PRODUCT & ENGINEERING BULLETIN

85748 Cummins Oil Filter Product Improvement

#99-1 3-8-99 WixHD

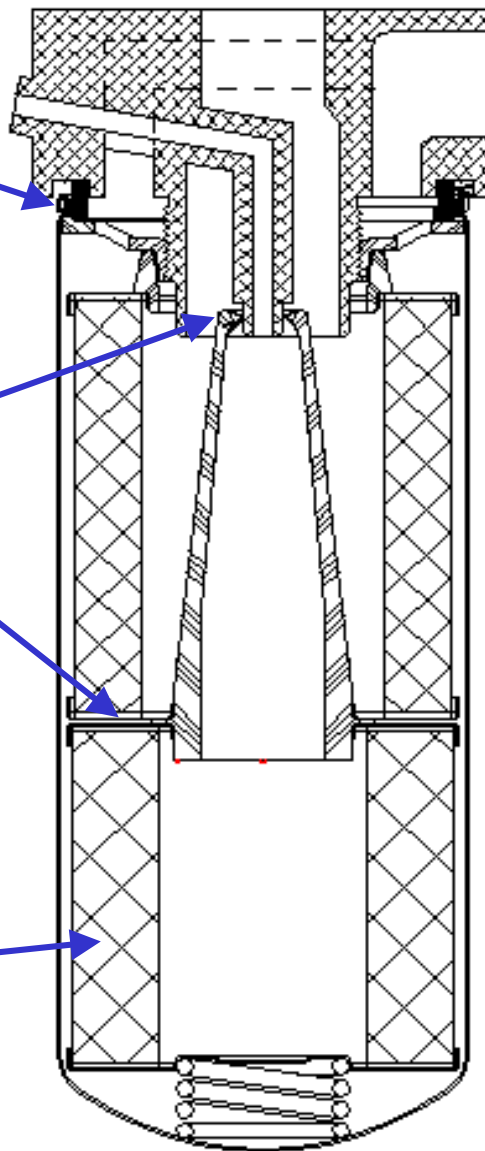
Lathe cut gasket to improve the seal between filter and filter base. There is no longer a pinch seal between filter seam and gasket

New flexible Self Centering flow separator which provides a positive seal between the full flow and bypass elements to insure proper filtration

Pleated synthetic media (developed in our racing program) used in our bypass element to remove engine sludge.
